STAFF RECOMMENDATION 3604 Richland Avenue January 16, 2019

Application: Partial Demolition; New Construction—Addition and Outbuilding

Description of Project: Application is to demolish a non-contributing portion of the rear of the house and to construct a rear addition, a side addition, a side dormer, and an outbuilding. The outbuilding will not be used as a Detached Accessory Dwelling Unit.

Figures 2 & 3 are photos of the existing frame portion of the house at the rear that will be demolished.

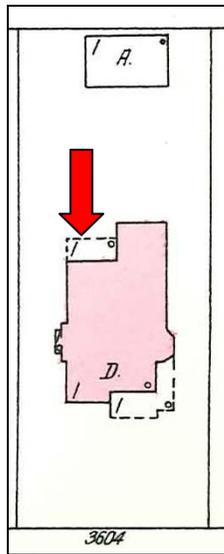
Demolition: The applicant proposes to demolish a frame portion at the rear of the house (Figures 2 & 3). The 1957 Sanborn map shows that at that time, the house had a frame porch at the rear, in this general location, but the existing structure today extends deeper than what the map illustrates (Figure 4). It is likely that the porch shown on the Sanborn map was either expanded or entirely reconstructed sometime after 1957. Although part of this addition may be older, staff finds that it does not contribute to the historic character of the house or the district because of changes and visibility. In addition, enclosed porches like this one were often constructed with lighter materials and framing so that after one hundred years, they are often either structurally unsound or have been

reconstructed already. This is porch is located at the rear of the house, where it is not highly visible from the street (Figure 5). Its location, lack of a proper foundation, flat roof form that is separate from the house, and the fact that it is not the same dimensions as the original rear porch all combine to make the rear porch non-contributing. Staff therefore finds that the proposed demolition meets Section III.B.2 for appropriate demolition and does not meet section III.B.1 for inappropriate demolition

SITE PLAN
1:40

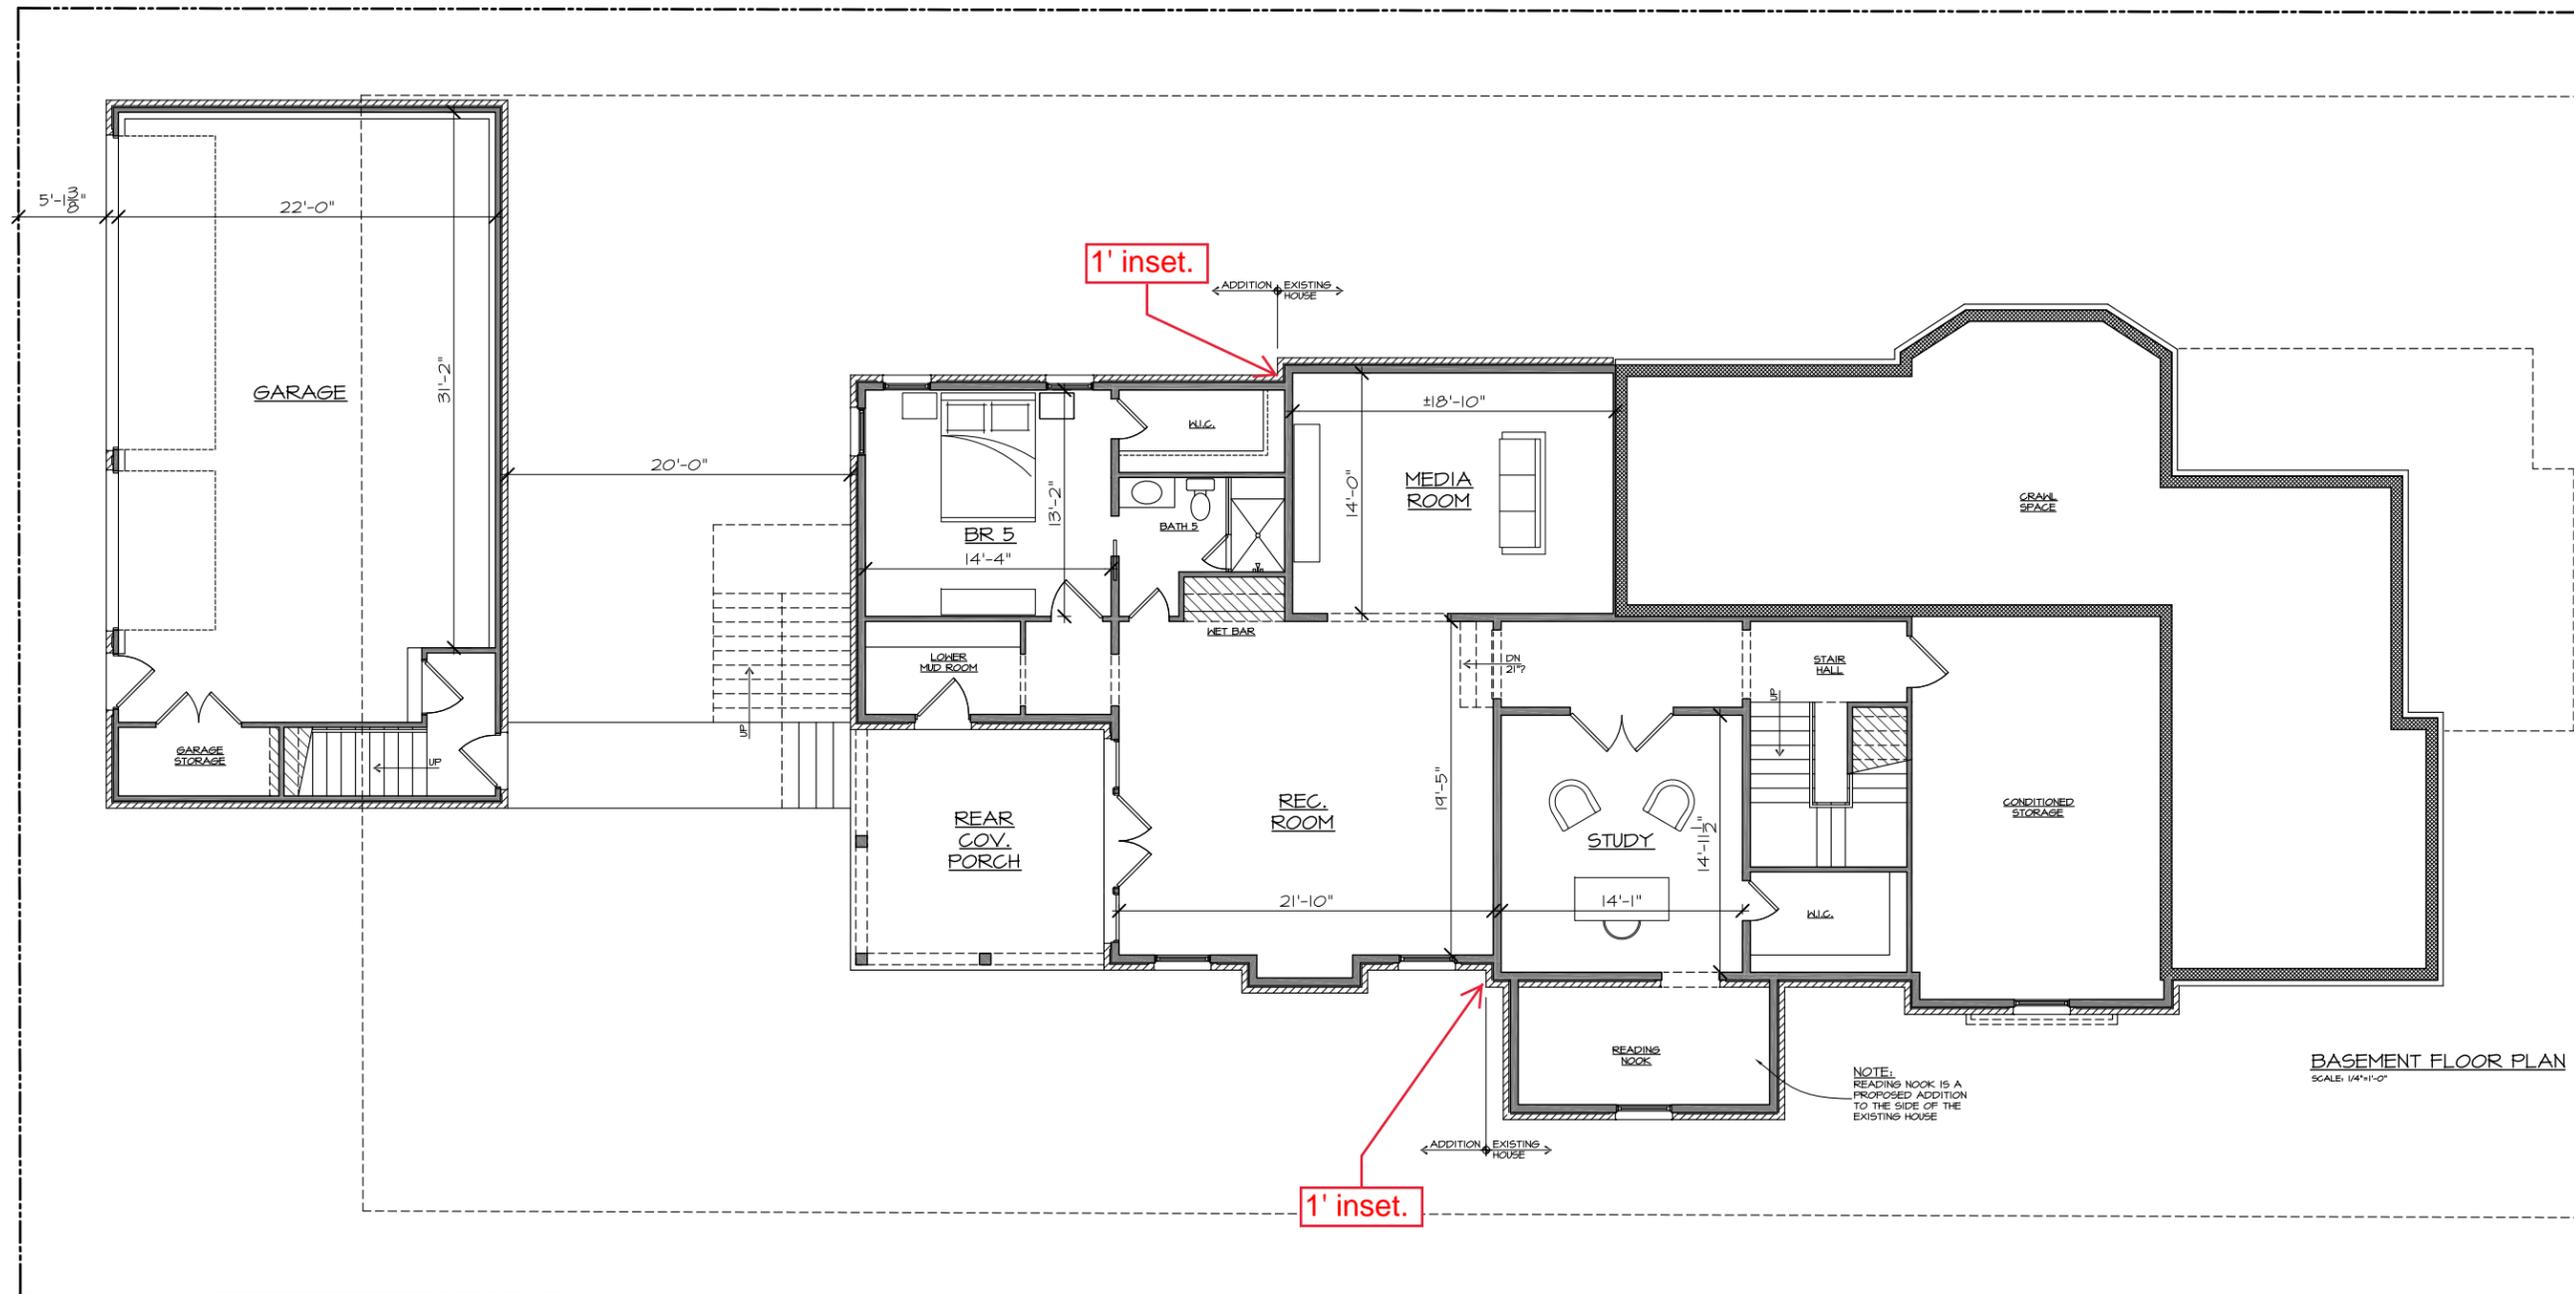
Setback & Rhythm of Spacing: The addition meets all base zoning setbacks. It will be twenty-one feet (21') from the right side property line, ten feet (10') from the left side property line, and forty-eight feet (48') from the rear property line. Since the side

addition is located towards the rear of the house, it will not alter the rhythm of spacing of houses along this part of Richland Avenue. Staff finds that the proposed project meets Sections II.B.1.c. and II.B.2. of the design guidelines.

MINIMUM	PROPOSED
Building located towards rear of lot		Yes
Space between principal building and DADU/Garage	20'	20'
Rear setback	5'	5'
L side setback	5'	28'6"
R side setback	5'	5'
How is the building accessed?		From alley
If the building is two-bay and the vehicular doors face the street, are there two different doors rather than one large door?		N/A

Staff finds that the outbuilding's location and setbacks meet the design guidelines.
